Duke Power Company

Oconee Nuclear Station

Proposed Technical Specification Revision

Extension of Oconee Unit 2

ROD POSITION LIMITS  
FOR FOUR PUMP OPERATION  
FROM  $150 \pm 10$  TO  $390 + 10$   
EFPD - 30  
UNIT 2  
OCONEE NUCLEAR STATION  
Figure 3.5.2-1B2

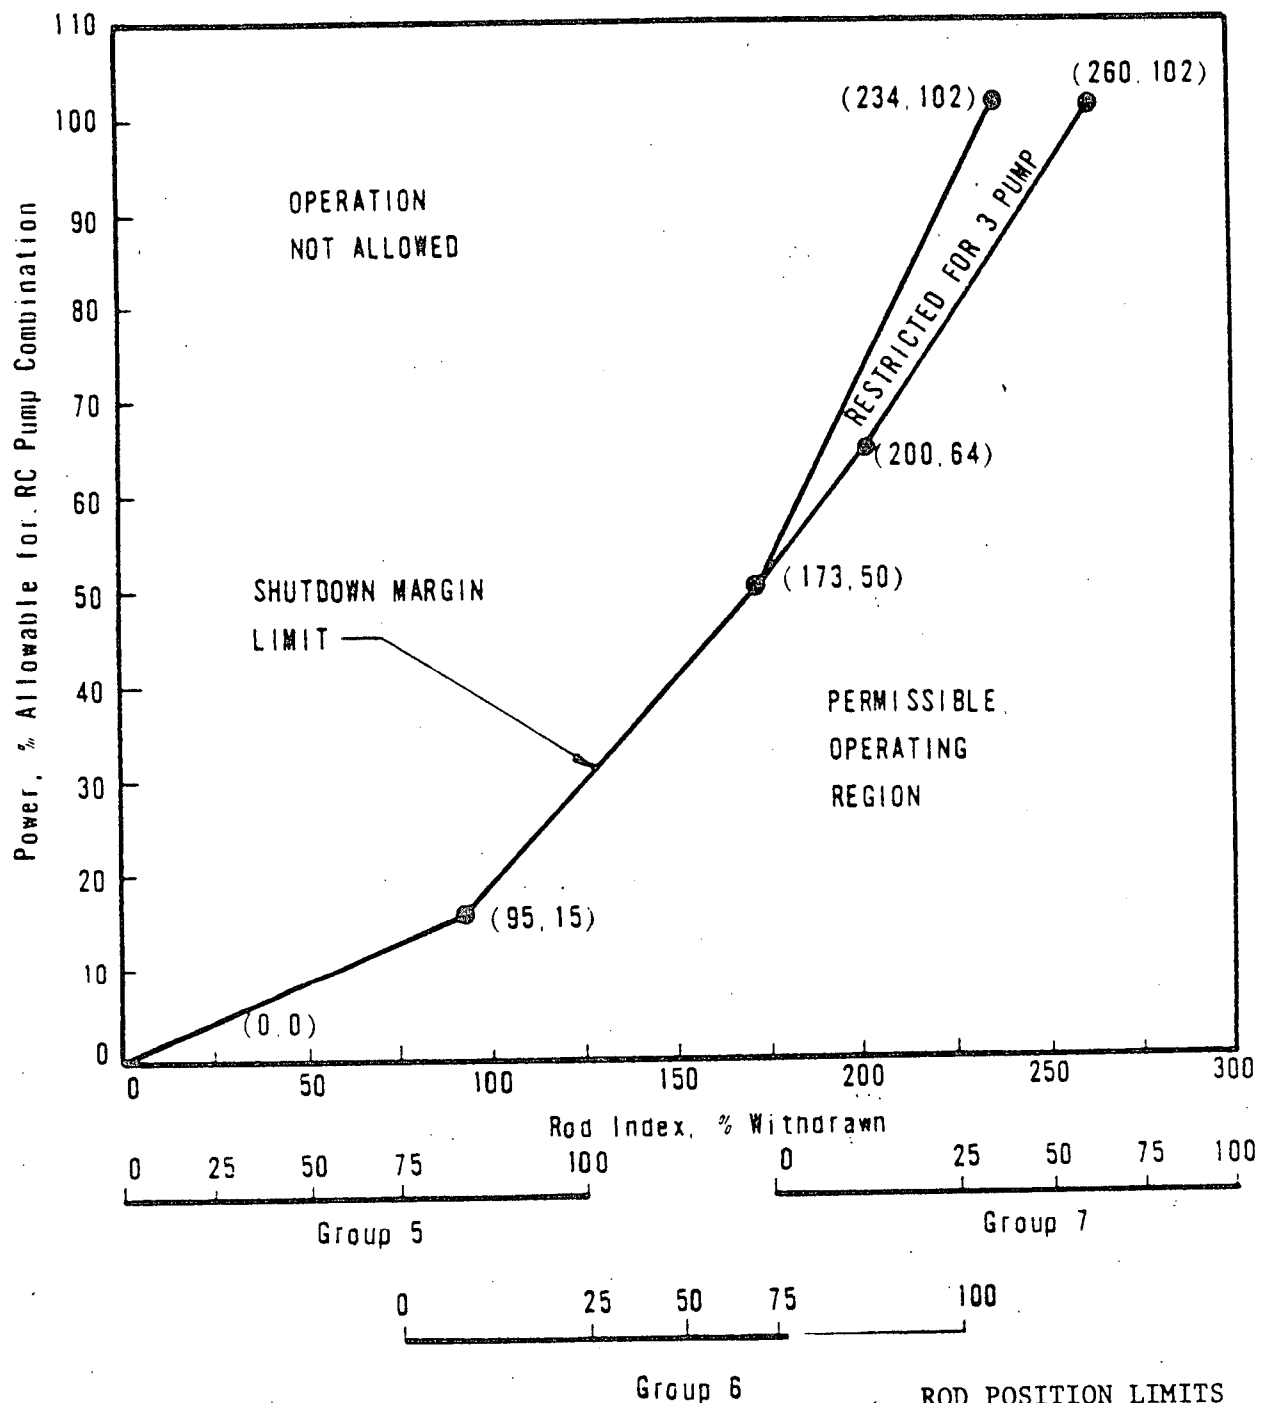
Operating Limits
